TCG121SV Series Package Change Notification

Please accept this letter as an official notification of the packaging change of TCG121SV series due to paper gasket reduction. Only TCG121SV series will be affected by this notification.

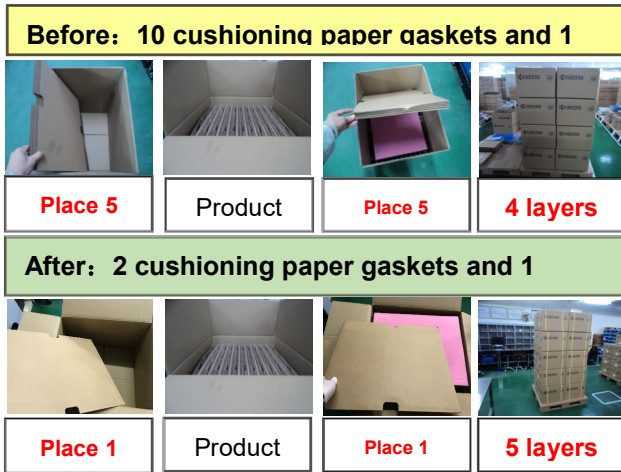
The number of paper gaskets change from 10 pieces to 2 pieces per box.

The height of each box is changed from 331mm to 290mm, other dimensions remain unchanged.

The quantity in each box remains unchanged.
